## S E R V I C E N O T E

**E1708A Remote Dynamic Receiver****Serial Numbers:** 3606A00101 / 3606A00300**Housing and Copper Tape May Cause Ground Loop Problems****To Be Performed By:** Agilent Qualified Personnel/Factory Only (SCD)**Parts Required:** See text.**Situation:**

Figure 1. E1708A-C01 with housing that should be replaced.

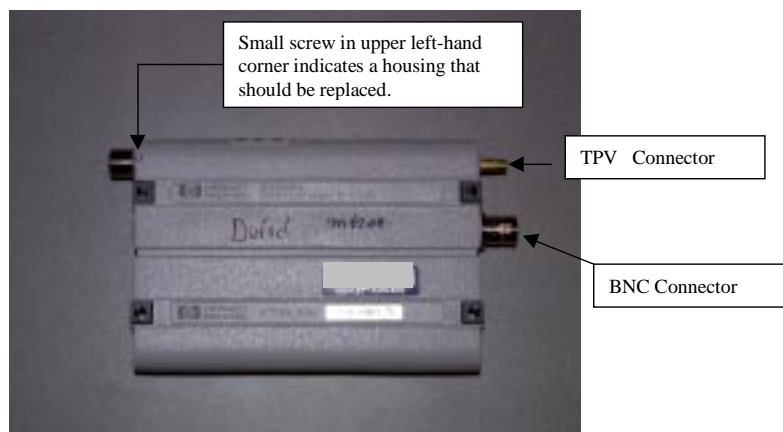
Units with serial numbers 3606A00101 to 3606A00300 were built with a housing that may or may not make a good ground contact with the BNC and TPV connectors. The resistance between these connectors should be zero ohms. However, we are finding that in some units, this resistance can vary between 0.1 and 390 ohms. This may cause a variable ground loop in our customers' machines. Furthermore, copper tape foil was used with this housing inside the Receiver. We know that ground loops and copper materials can be quality issues for our customers. Figure 1 shows how to identify an E1708A with the affected housing.

As a result, Agilent is offering to replace these units with ones that have a new housing and no copper tape. The new housing is a tighter fit and is not subject to this ground problem. The replacement unit will be identified as E1708A-C10, which will be a refurbished E1708A with a new serial number.
